ST MARY'S HOUSE, READING
DESIGN & ACCESS STATEMENT ADDENDUM

RA-1065-PL-MAR 26-REV.A

St Mary's House,
75-76 Broad Street and 66-68 St Mary's Butts,
Reading,
RG1 2LG

Extant Consent - First Floor Plan

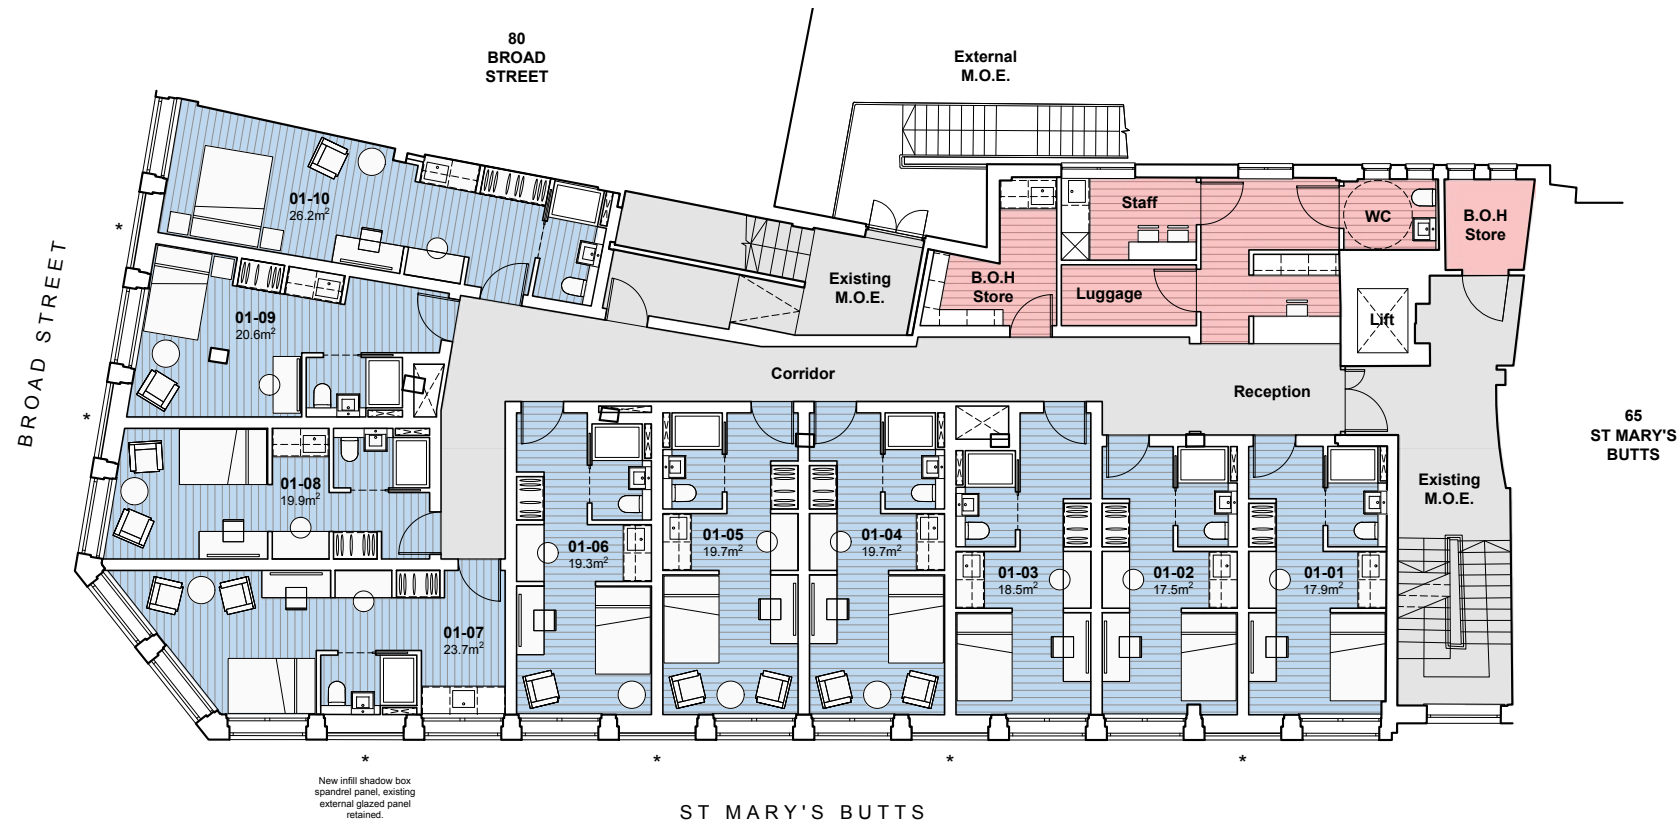
At first floor, the small amenity space which is excess to end user requirements, is proposed to be replaced by a serviced apartment - increasing the numbers on the first floor from 9 to 10.

This amendment does not affect the external elevation or change the GIA.

Extant Consent - Fourth Floor Plan

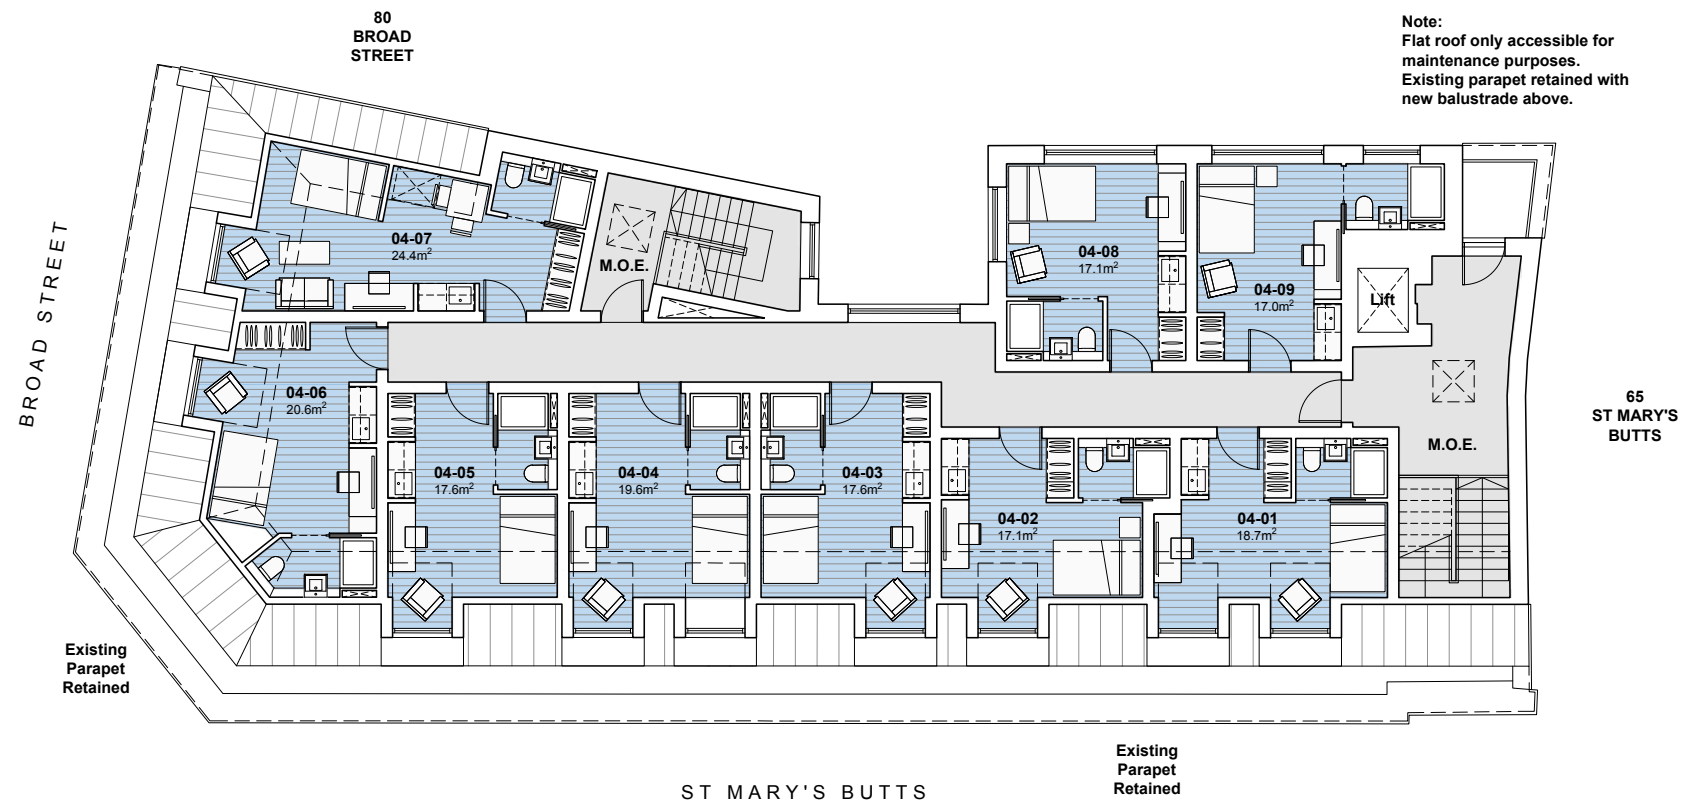
At the new fourth floor, end user requirements and advise necessitated the removal of larger units, which do not fit the model, in favour of a greater number of smaller units (similar in size to the floors below).

The proposed internal re-arrangement increases the number of serviced apartments at this level from 6 to 9 - an increase of 3 units.

Critically, these amendment do not affect the external elevation, window openings, or change the GIA.
